Regular Meeting  
12/5/2017  
R-4  
Provided by  
John Roth

T.R.R. BAHIA MAR,  
1175 NE 125 STREET, SUITE  
NORTH MIAMI, FL 33161

Sheet Title:  
SITE PLAN

L-201

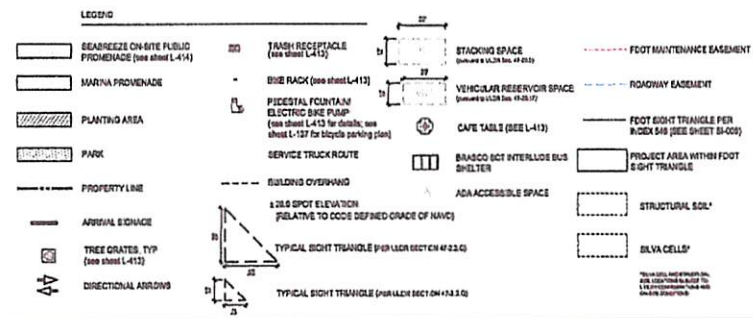
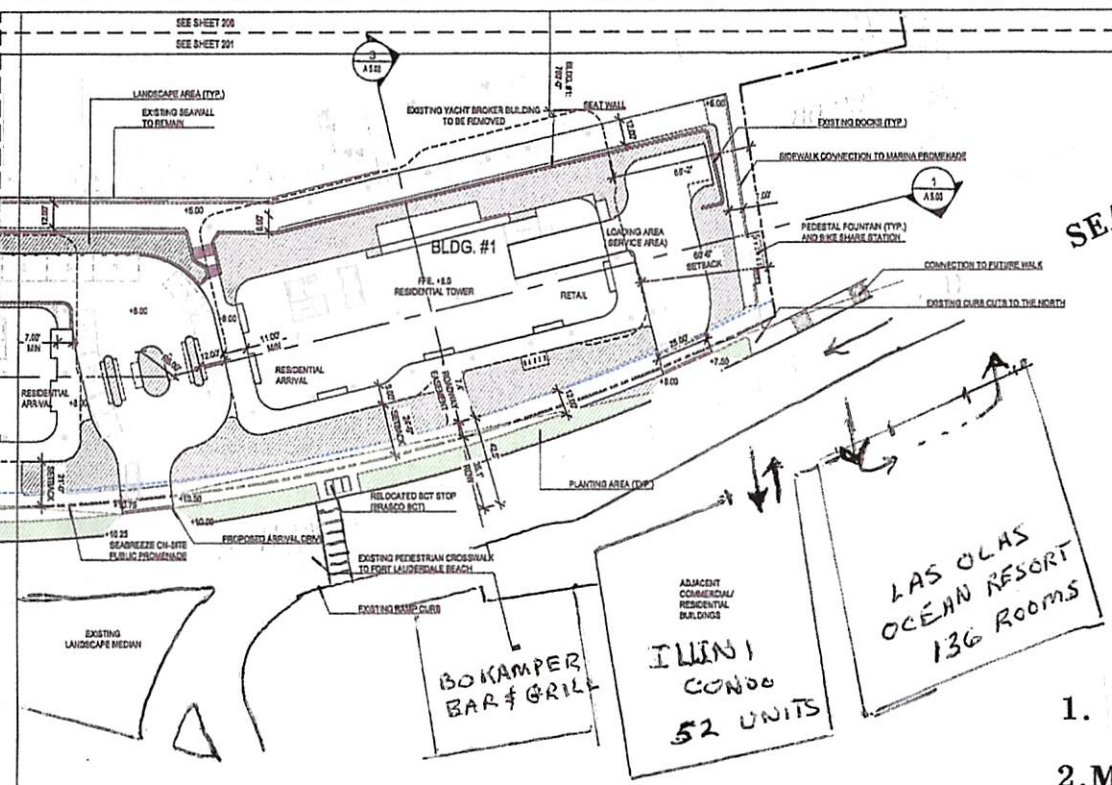
The applicant, per the drawing before you is proposing two large buildings on the north end of the project called building one and two ~~believe~~ and they have a singular driveway to access from the state route A1A.

The building's main driveway access is on a blind curve which is just across the street from Bo Kampers restaurant. There is a crosswalk there, and a new bus stop is proposed just at the crosswalk. A wide pedestrian sidewalk runs all along the front of the buildings. There is a single bicycle lane on the roadway.

The problem is, since there is no deceleration lane, it will be very difficult to slow down and get in and out of the building's main entrance safely. These two buildings alone will generate a LOT of traffic, alone added to the confusion created by the high volume crosswalk going to Bokampers and the beach, plus the bus stop, and many bicycles coming out of the project going both North AND South.

## NEEDS

1. Deceleration Lane for Bldg 1&2 Driveway
2. Maintain wide Sidewalk
3. Provide wide bicycle lane OFF roadway.
4. Review BCT Stop location.

## NEEDS

1. Deceleration Lane for Bldg 1&2 Driveway
2. Maintain wide Sidewalk
3. Provide wide bicycle lane OFF roadway.
4. Review BCT Stop location.
